# Receiver Sensitivity Analysis for Baseline Proposal

R. Nering

IEEE P802.3db Short Reach Fiber Task Force Interim

# Changes Proposed

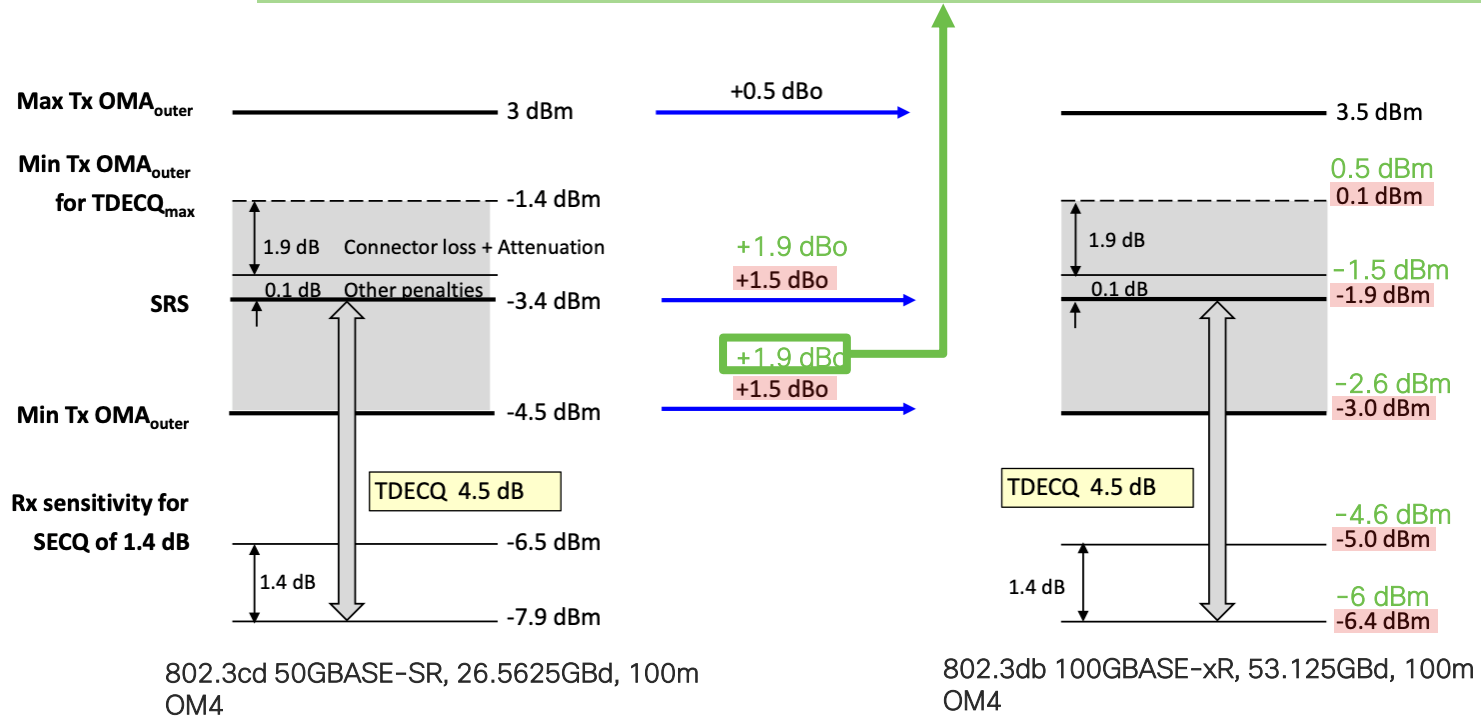
Issue with the current baseline proposal:

- 1.5dB of signal power increase is needed just to maintain SNR when bandwidth doubles while noise density remains the same.
- Other factors such as noise density degradation by bandwidth scaling, DSP quantization noise and crosstalk can result in additional penalty.

Propose to add 1.9dB instead of 1.5dB for 100G to allow some margin at RX
